Sheet: /
File: mag-encoder.kicad_sch

Title: Mag Encoder (WCP-1971)

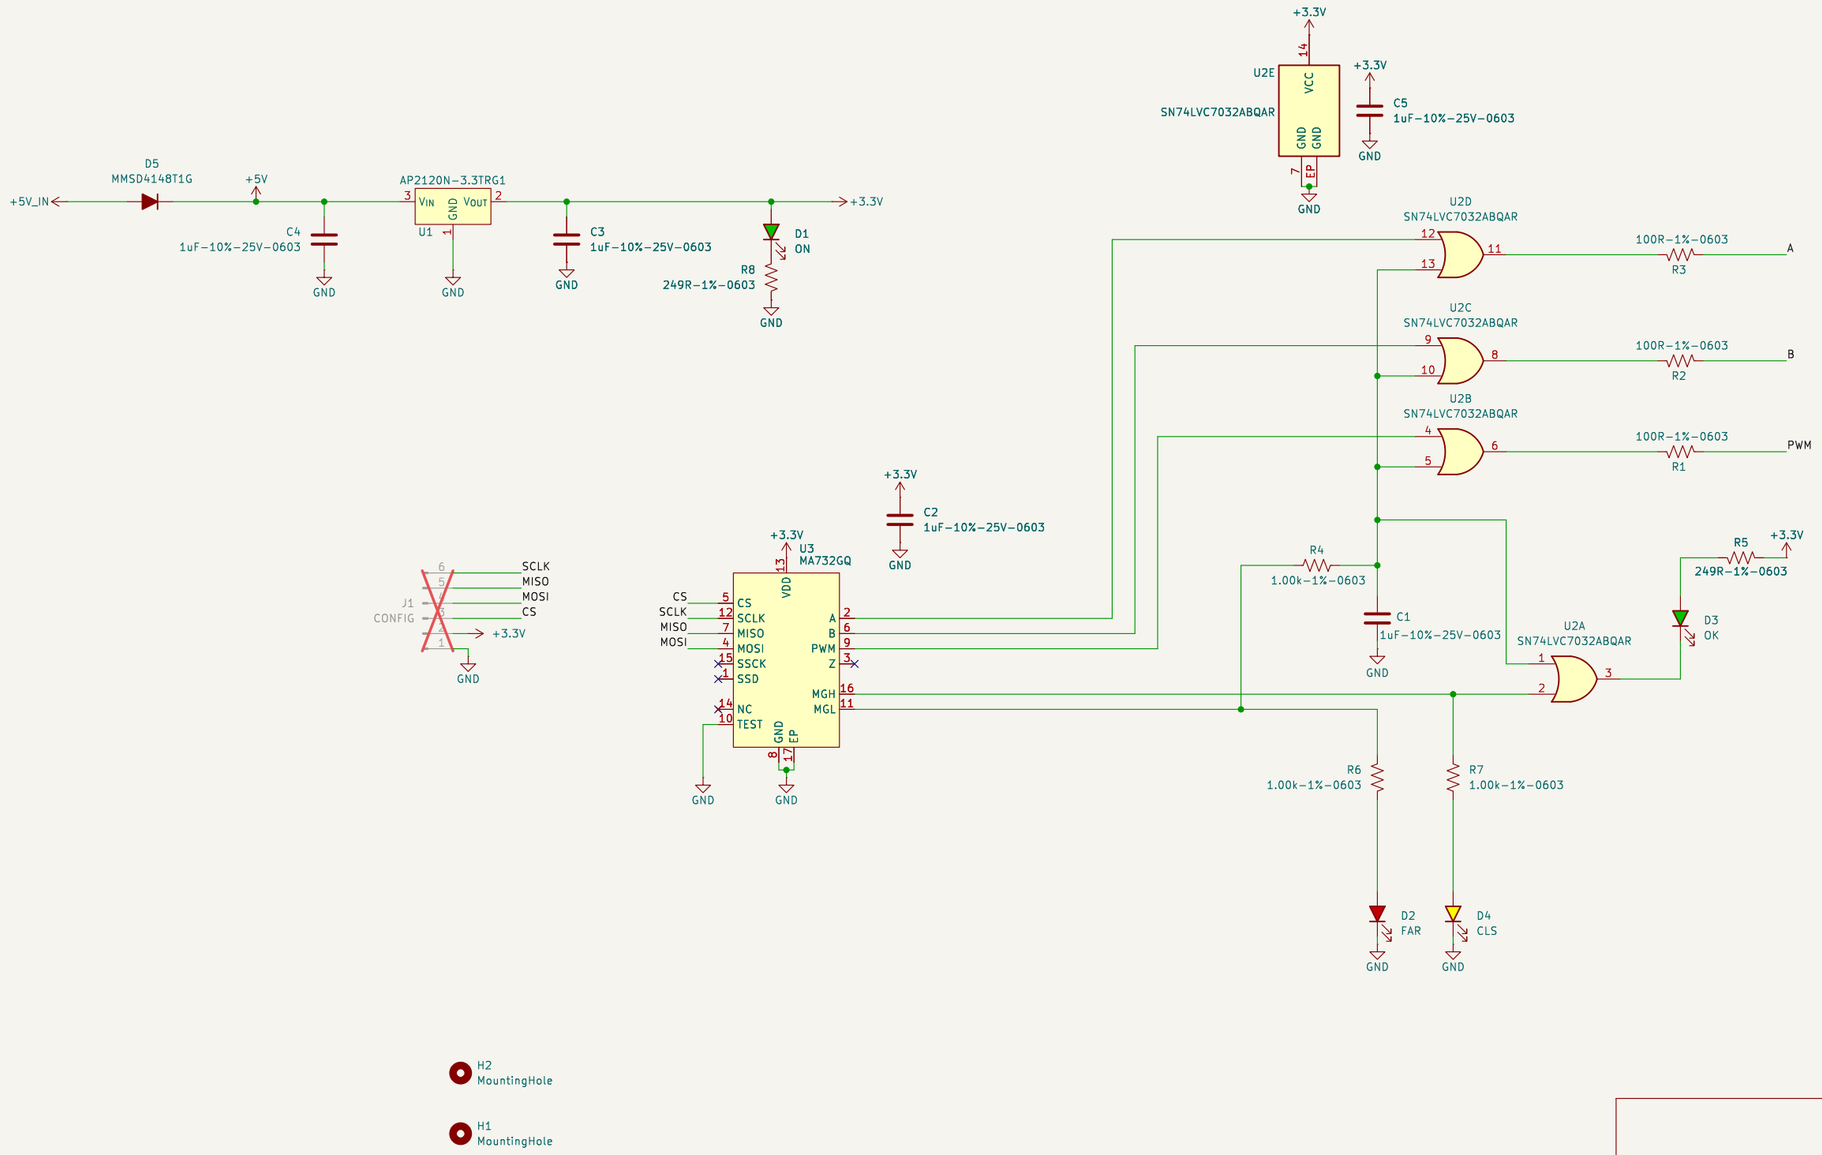
REVISION NOTES
==========
Rev 1: Initial Design
Rev 2: PCB rounded to fit inside bearing
Rev 3: Locating pins changed to 3mm.
Board cut under SL connector.
Rev 4: Add OR gate to disable outputs
when mag field is weak.
Increase green led brightness.
Reset to Rev1 from 971 Archive
